LARAMIE COUNTY PLANNING & DEVELOPMENT DEPARTMENT

MEMORANDUM

TITLE: PUBLIC HEARING: Subdivision Permit and Plat for Conley Ranch, a portion of land in Section 30, T14N, R61W, 6th P.M., Laramie County, WY.

CONLEY RANCH SUBDIVISION
PERMIT AND PLAT

**CONLEY
RANCH**

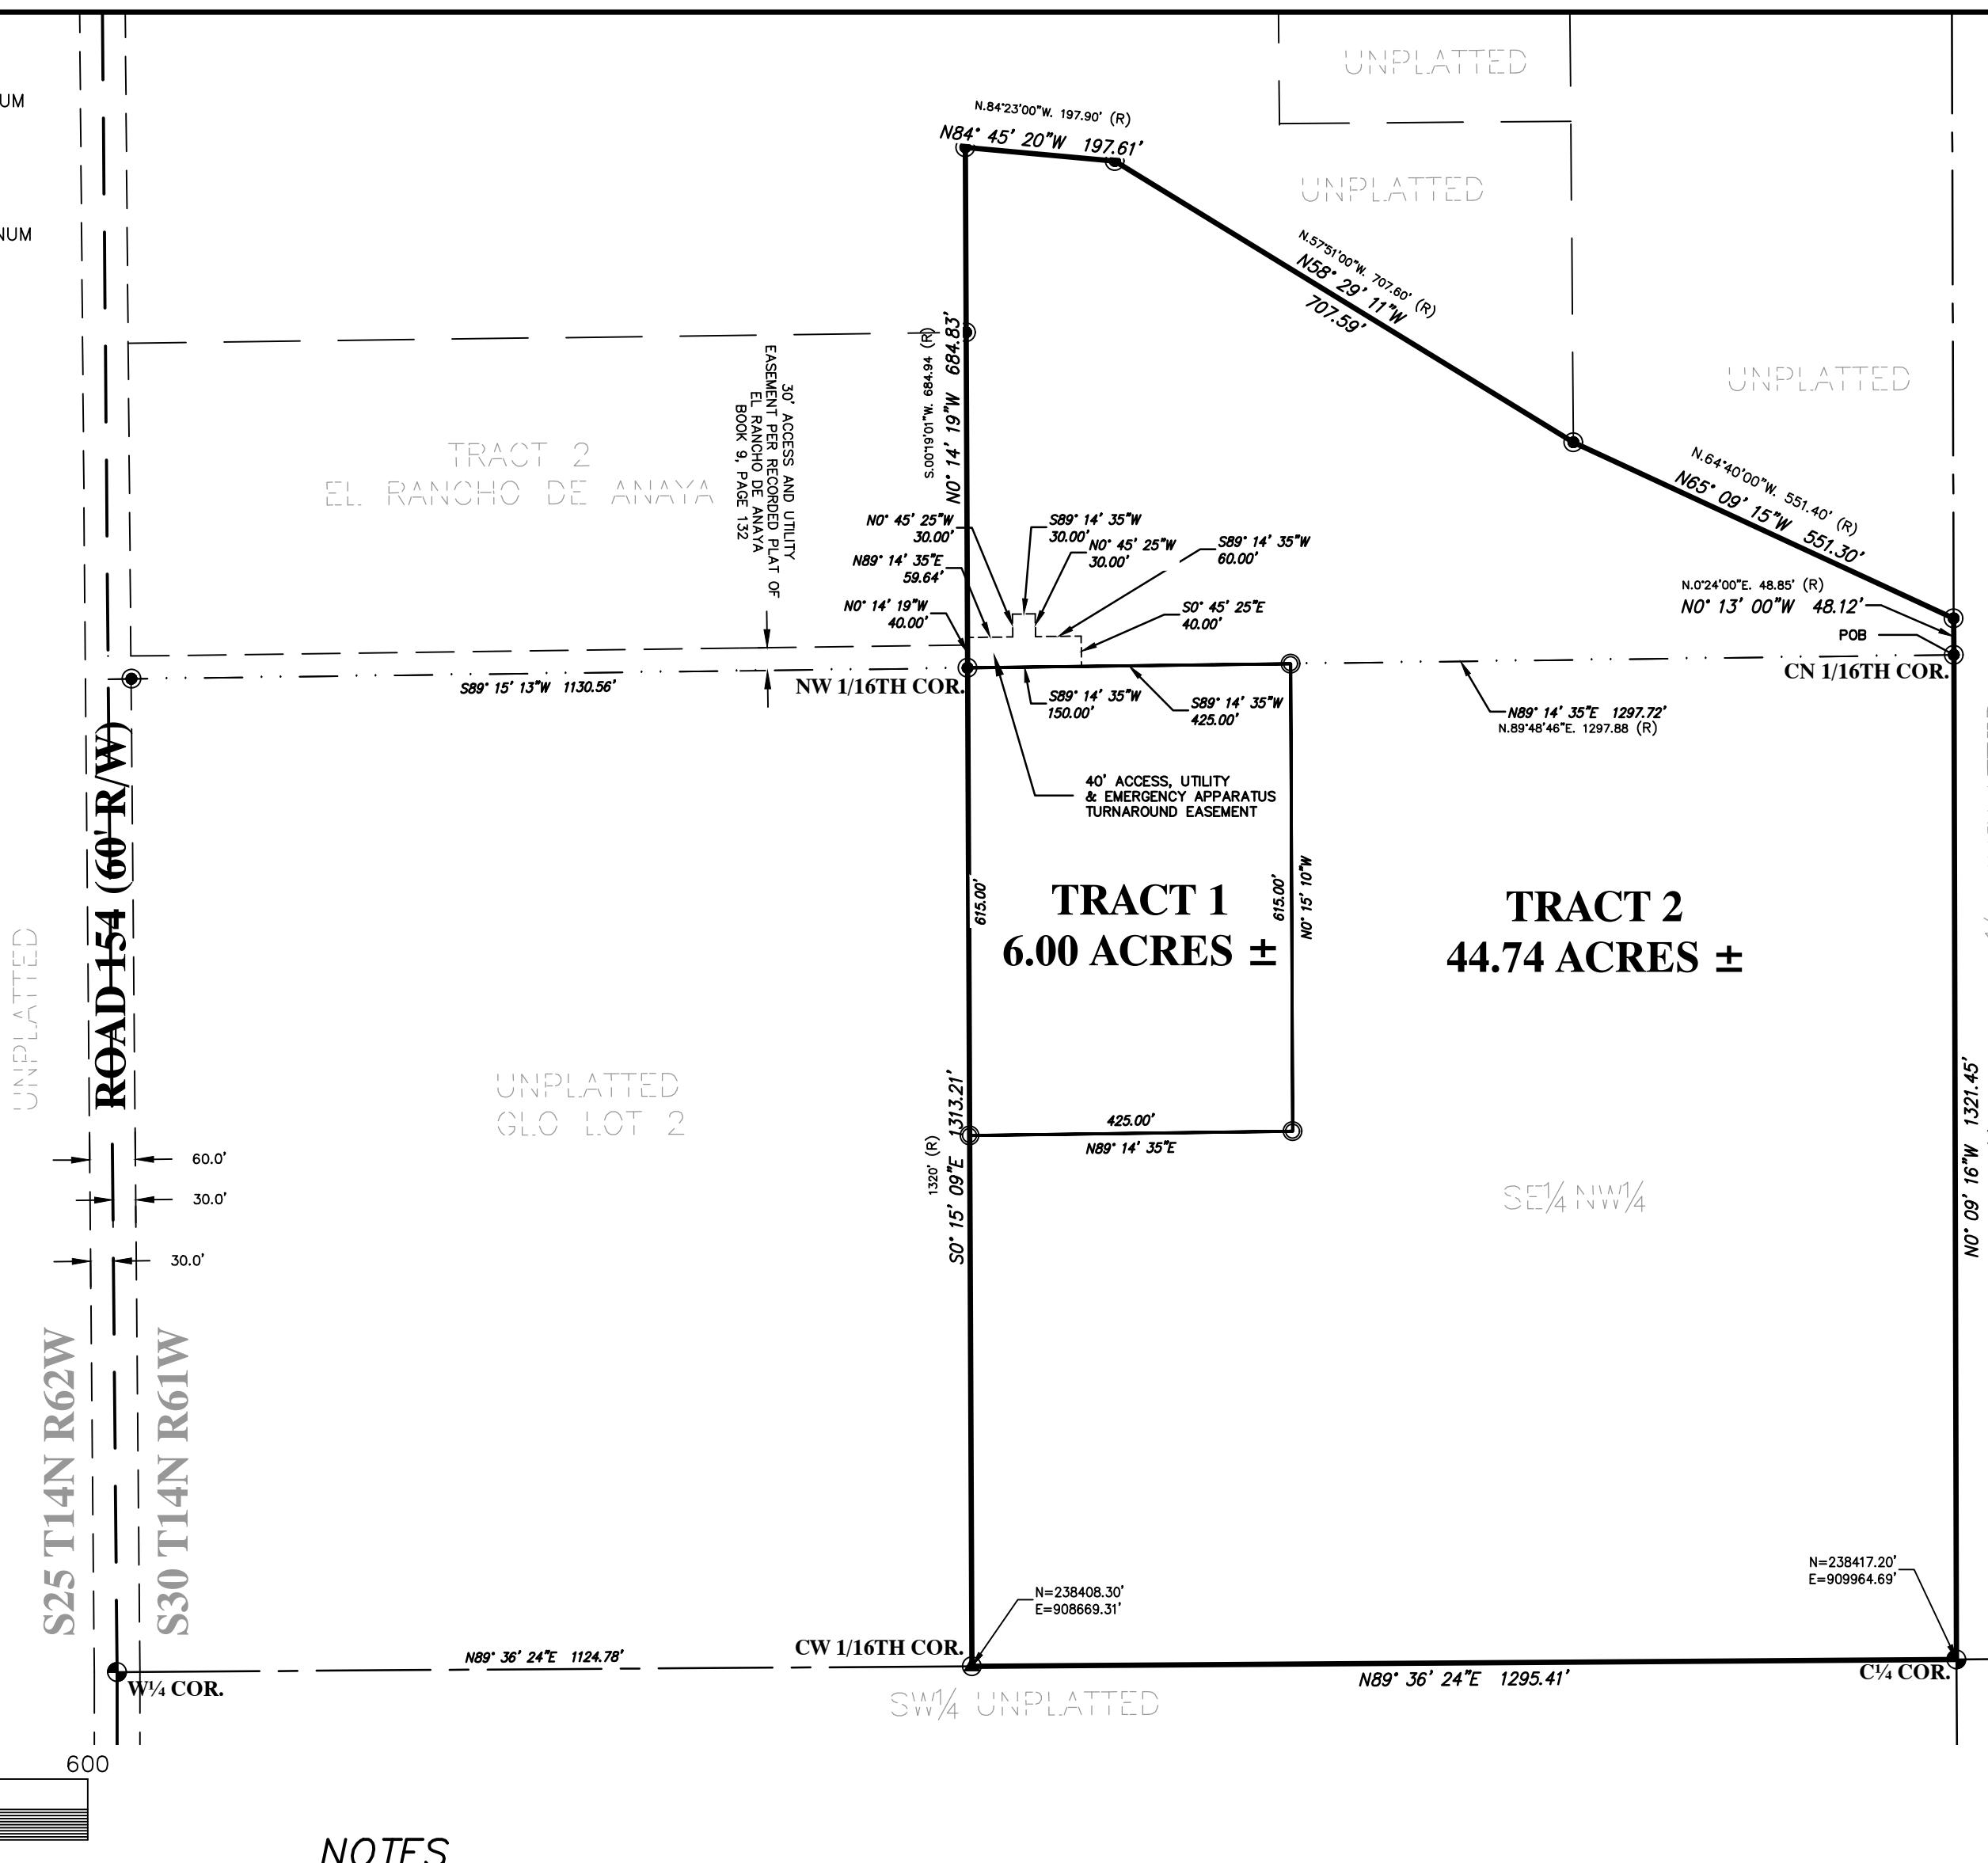
12/19/2025	Application	PZ-25-00080	GENERAL	Please see attached review.	SUE.KINSLEY@LA RAMIECOUNTYWY .GOV
12/19/2025	Workflow	ENGINEERS REVIEW	GENERAL	<p>1st Review Engineers Comments</p> <p>1. The existing and proposed 30' access and utility easement for access to these two Tracts needs to be increased to 40' in order to meet the requirements in 5-6-109.f. The access road and easement are required to be designed and constructed to meet the requirements in this section of the LCLUR and design/construction plans for the roadway shall be submitted to the County for review and approval. By complying with this regulation, the County is willing to forgo meeting the requirements of 4-5-103.vii.D.</p> <p>2. Per 5-4-102.c, Note 5 on the plat should say "There shall be no public maintenance of internal roadways or access easements".</p> <p>3. Per 5-2-106, this plat does not meet the requirement for a Preliminary Drainage Report since it includes less than 5 rural lots/tracts. A waiver of a drainage report is not necessary since it does not meet the requirement for a drainage report.</p> <p>4. Since it is the intent of the County to amend the regulations regarding Transportation Worksheets in the near future, it is agreed that a worksheet is not needed with this plat since it only involves 2 rural residential tracts.</p> <p>5. Any additional replatting of either one or both of these tracts will require the applicant to fully comply with section 4-5-</p>	SCOTT.LARSON@ LARAMIECOUNTY WY.GOV

6.The year on the approvals may need to be changed to 2026 if signatures are not obtained prior to the end of this year.
 7.The plat shows some of the property lines with measured and recorded bearings and distances, but not all lines show both and they need to show both for the original property lines. In addition, the Dedication uses the recorded bearings and distances instead of the measured bearings and distances. This is fine because both recorded and measured bearings and distances are shown on the plat drawing, however, it is common, industry standard, and the correct thing to do to note in the Dedication that it is utilizing the recorded bearings and distances instead of the measured ones.

1.In the third line of the DEDICATION, "portion of the NE1/4NW1/4" should be "portion of the NE1/NW1/4 and all of the SE1/4NW1/4".
 2.On the west boundary of the subdivision, with reference to the segment of the line from the NW1/16 COR to the northwest corner of TRACT 2, is the length of this line segment the same as the record length of 684.94? I assume it is the same, but the only length labeled is the record length.

was established via a plat, but the roadway within the easement was not designed and/or built to county standards. Therefore, this access easement cannot be utilized for access to this subdivision per the regulations and you will need to find one that complies with the regulations.

2. The plat shows some of the property lines with measured and recorded bearings and distances, but not all lines show both and they need to show both for the original property lines. In addition, the Dedication uses the recorded bearings and distances instead of the measured bearings and distances. This is fine because both recorded and measured bearings and distances are shown on the plat drawing, however, it is common, industry standard (per PLSSs throughout the entire State), and the correct thing to do to note in the Dedication that it is utilizing the recorded bearings and distances instead of the measured ones.

3. In the third line of the DEDICATION, portion of the "NE1/4NW1/4" should be portion of the "NE1/4NW1/4 and all of the SE1/4NW1/4".

1. Mr. Larson you are a recommending body only. You have no approval authority. We will speak to the Board about the continued over reach of the LCLUR. We meet your requirement by the platted access easement approved by the Board.
- 2 and 3 - The dedication and plat are as our licensed surveyor requires. You are not a Licensed Surveyor. The dedication and plat are correct and will remain as they are.
